ADDENDUM No. 1

RFP No. 24-20

Huron River Drive Culvert Replacement

I. CORRECTIONS/ADDITIONS/DELETIONS

WATER MAIN

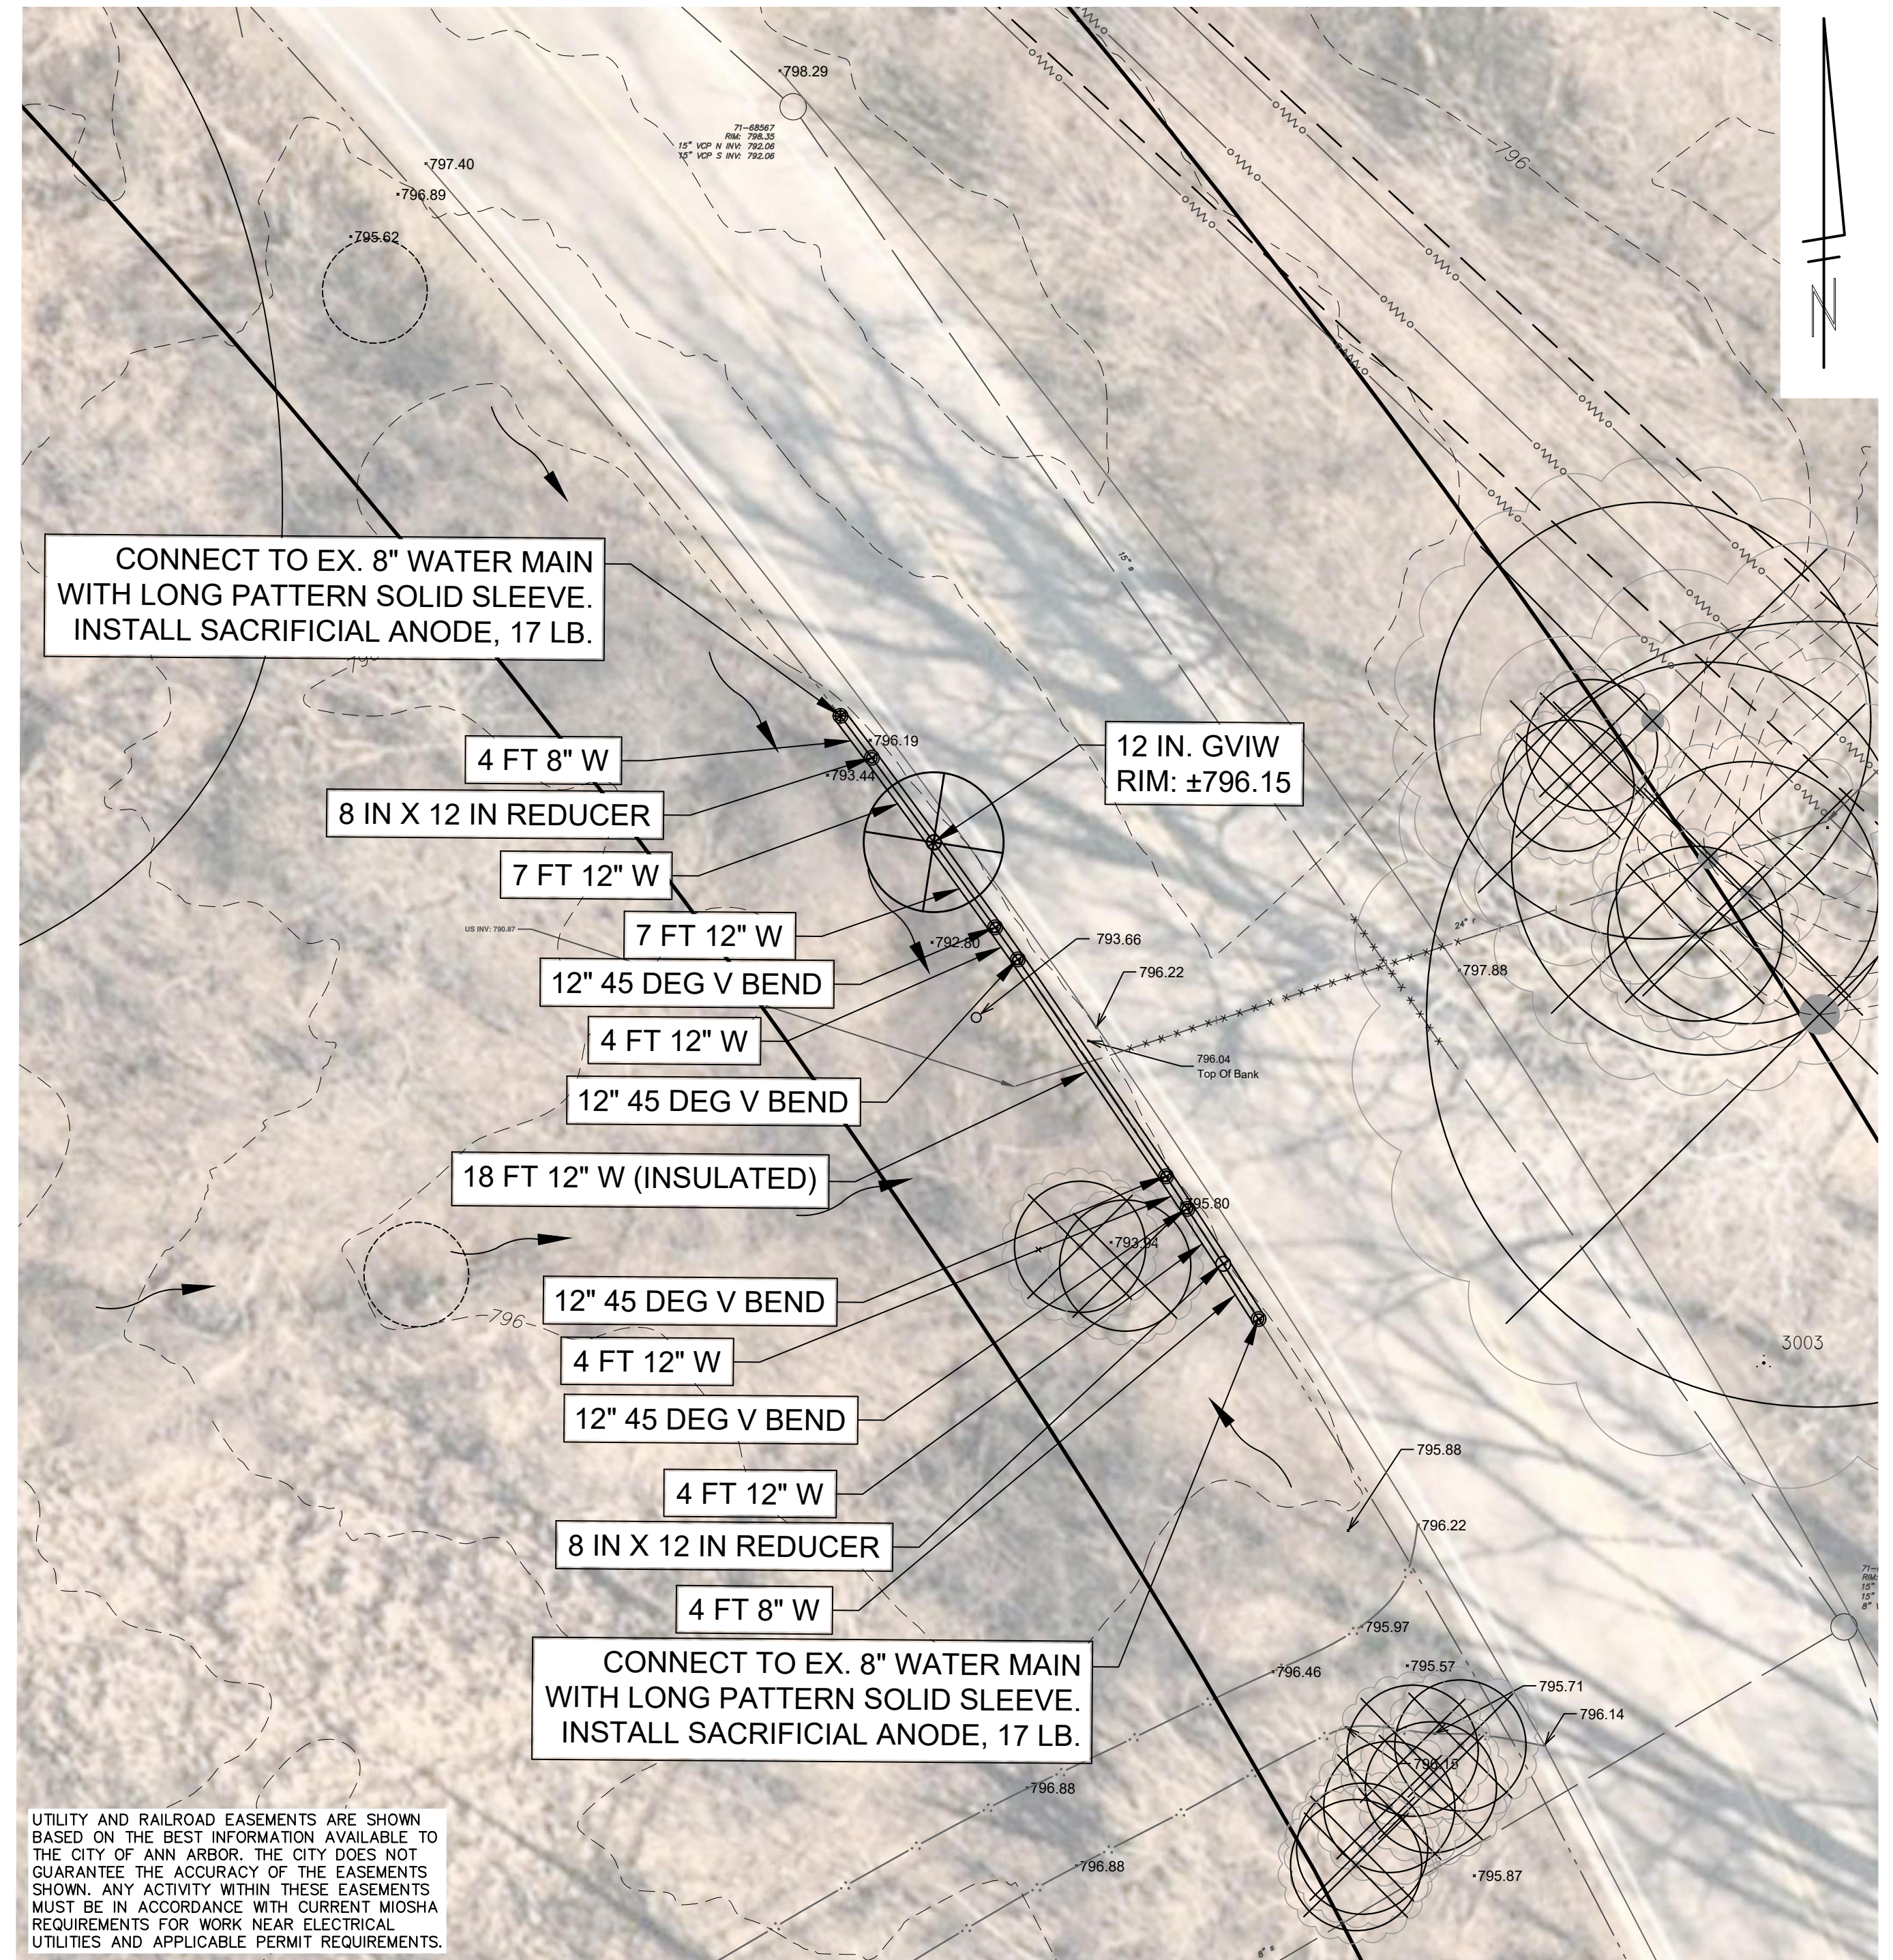
8. WATER MAIN, WHERE INDICATED IN THE PLANS, OR AS DIRECTED BY THE OWNER, SHALL BE INSULATED IN ACCORDANCE WITH THE DETAIL GIVEN ON SHEET 5. ALL LABOR, MATERIALS, AND EQUIPMENT REQUIRED TO INSULATE WATER MAIN IN ACCORDANCE WITH THE REQUIREMENTS OF THESE PLANS SHALL BE CONSIDERED INCIDENTAL TO THE UNIT PRICE BID FOR THE ITEM(S) "___ IN., PC 350 DIP W/POLYWRAP, SD-TD-1 - FT," AND WILL NOT BE PAID FOR SEPARATELY.
